**AGENDA
MANOR PLANNING AND ZONING COMMISSION
105 E. EGGLESTON ST.
MANOR, TEXAS 78653
OCTOBER 14, 2015, 6:30 P.M.**

Re: First Construction Plan and Final Plat Review for
Shadowglen Phase 2, Section 20 Subdivision
City of Manor, Texas

Re: Stonewater North Subdivision
Fourth Preliminary Plan Application Submittal
City of Manor

Re: First Final Plat Review for
Presidential Heights – Phase 1
City of Manor, Texas

STONEWATER NORTH
PRELIMINARY PLAT

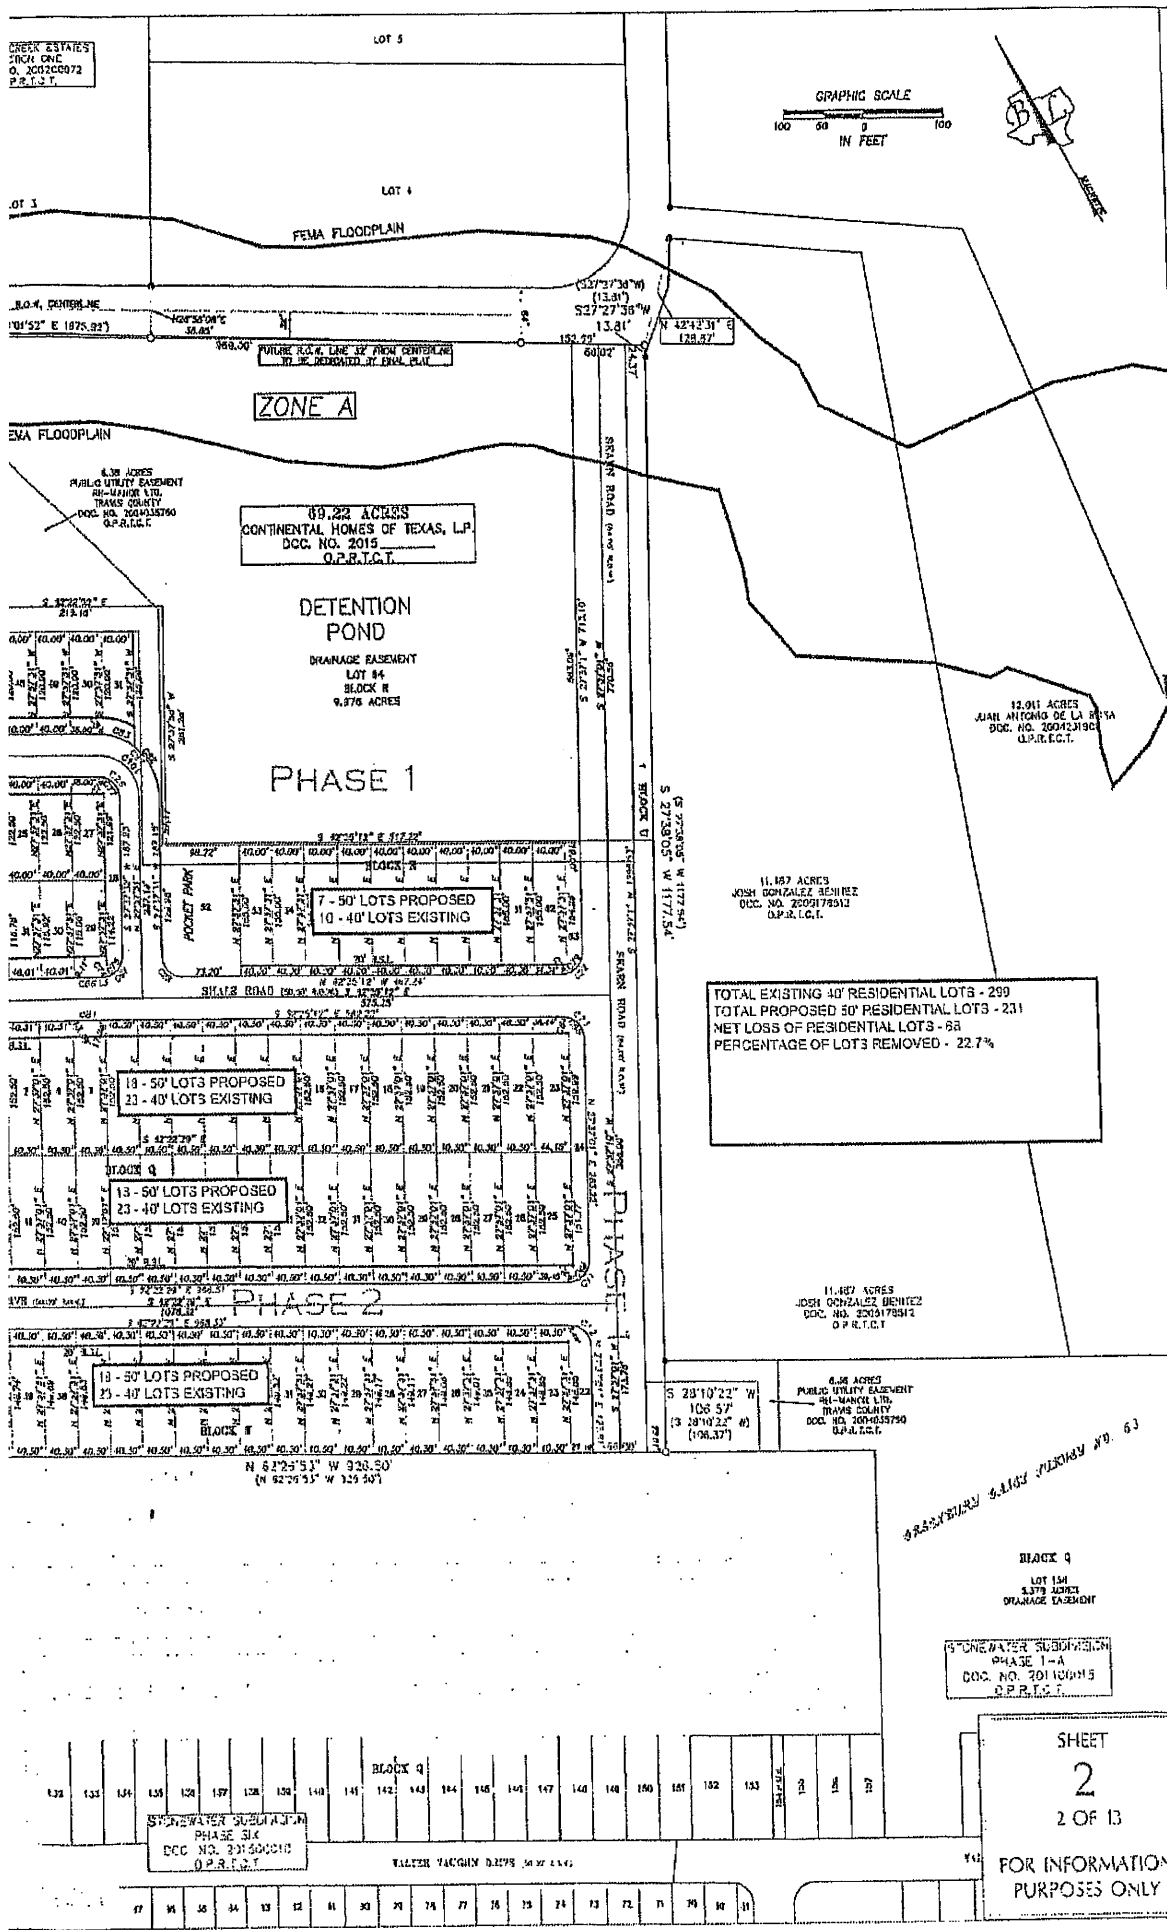
The Stonewater North Subdivision Preliminary Plan submitted by Doucet & Associates and received by our office September 10, 2015, has been reviewed for compliance with the City of Manor Subdivision Ordinance 263 B. Our previous comments dated July 7, 2015, have not been addressed with the latest submittal. The previous comments were:

1. Provide verification of no significant trees within the Limits of Construction as required by Section 22(c)(2)(iii) of Subdivision Ordinance 263 B. Significant Trees, within the boundaries of the subdivision and of 8-inch caliper and larger, shall be shown accurately to the nearest one (1) foot, Critical Root Zones of these trees shall also be shown.
2. An easement will be required for the fully developed 100 year flood plain, based upon the submitted memorandum. Show easement on the plan as required by Section 22(c)(4)(i) of Subdivision Ordinance 263 B. A drainage study, consisting of a Drainage Area Map with contours, location and capacities of existing and proposed drainage features, and calculations in accordance with this Ordinance and good engineering practices, shall be provided to ensure the property will be developed in accordance with City drainage policies.

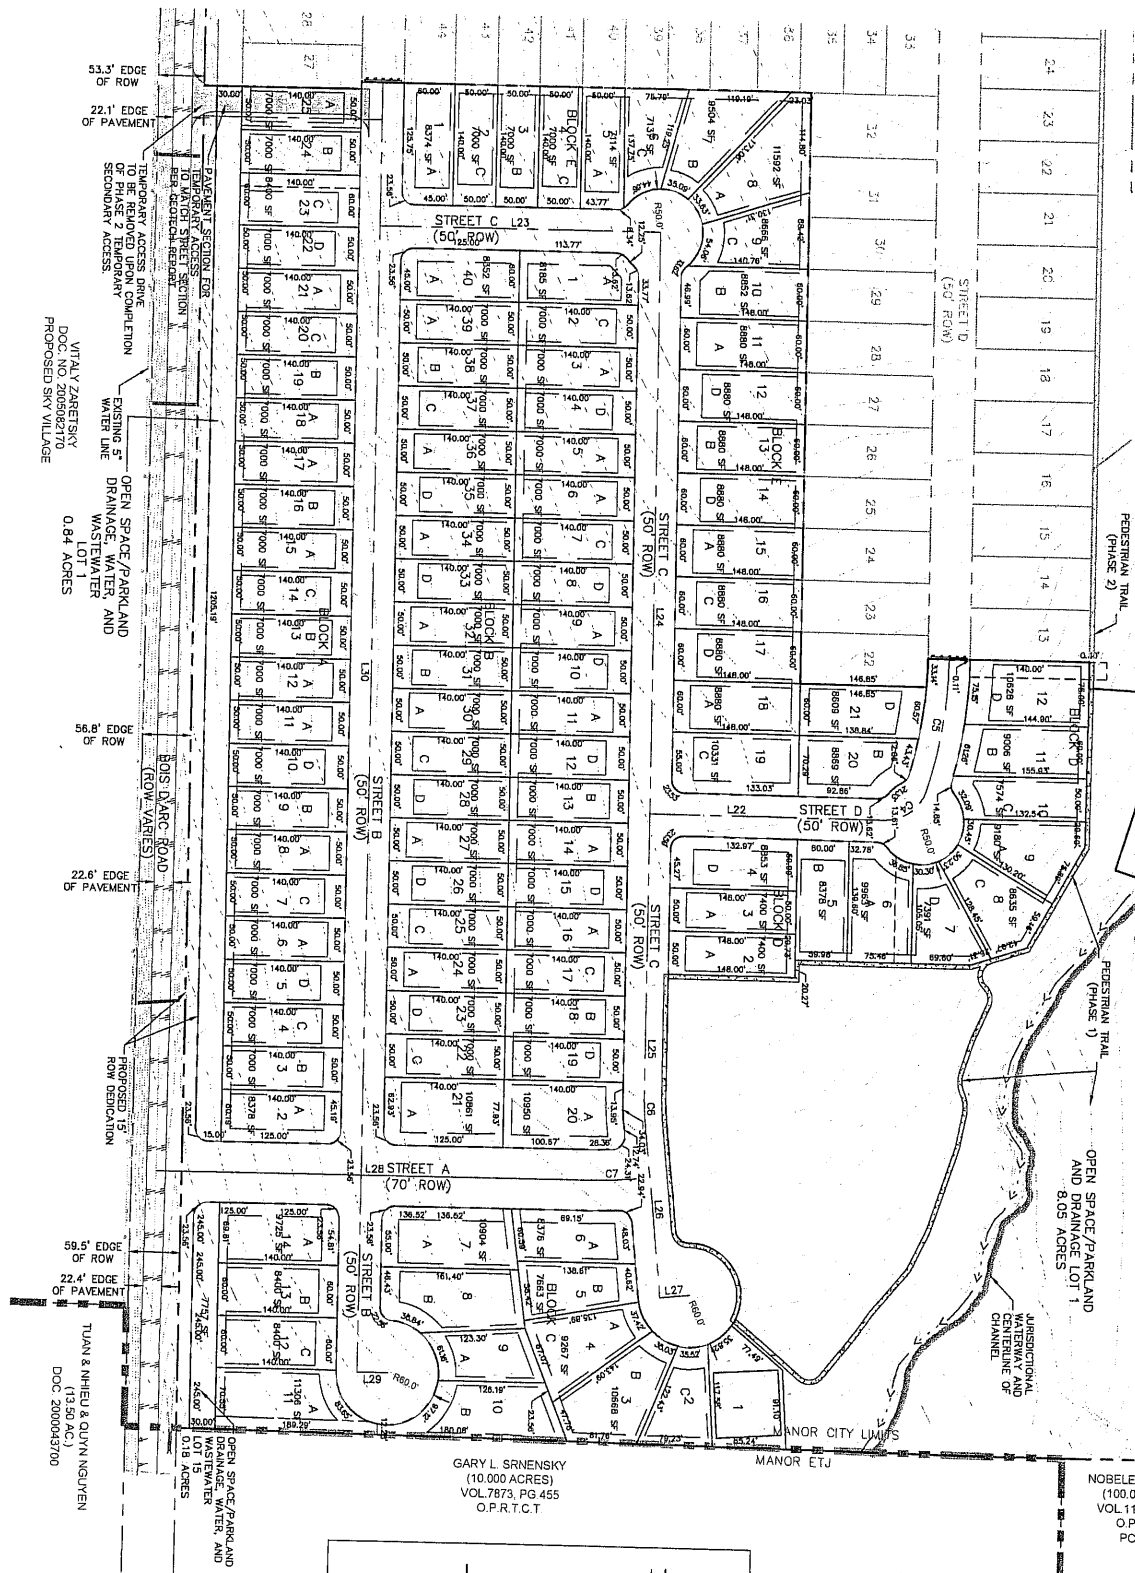
1. The location map on the plat is not to scale as required in Section 24(c)(1)(iii) of Subdivision Ordinance 263B. A location map showing the relation of the subdivision to streets and other prominent features in all directions for a radius of at least one (1) mile using a scale of one (1) inch equals two thousand feet (1" = 2,000') must be shown on the plat. The latest edition of the USGS 7.5 minute quadrangle map is recommended.

3. The Subdivision Final Plat Application shows fees calculated for a total of 113 Lots, but the plat shows 116 total lots.
4. Documentation on 911 Addressing approval of new street names is not provided as required in Section 24(c)(1)(xi) of Subdivision Ordinance 263B. Where new streets are being created and named, the applicant must have documentation from Travis County 911 Addressing demonstrating that the street names proposed on the Final Plat are not duplicated within the County.

5. No right of way widths are shown for the proposed streets. Section 24(c)(4)(i) requires that the location, bearing, distances, widths, purposes and approved names of proposed streets, alleys, easements and rights of way to be shown.

6. Section 24(c)(4)(ii) requires that complete curve data (delta, arc length, radius, tangent, point of curve, point of reverse curve, point of tangent, long chord with bearing) be provided.

7. Block E Lot 20 is missing dimensions. Section 24(c)(4)(v) requires the use, property dimensions, names and boundary lines of all special reservations to be dedicated for public use.
